Access Compliance Report

Public Rights-of-Way

(Curb Ramps)

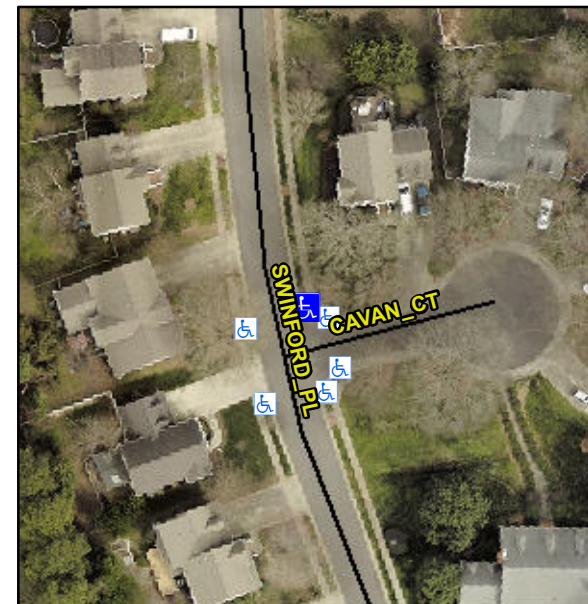
Intersection ID: 24562	Main Street: CAVAN_CT	Cross Street: SWINFORD_PL	Location: NE
ADA ID: 5D3454308E13	Ramp Type: Perp	Initial Pass/Fail: Fail	Overall Compliance: No
Severity Score: 8.75			
Codes/Mitigation Info/Possible Solution		Field Measurements/Component Compliance

Not Found, R304.5.1

Remove & Replace Entire Ramp.
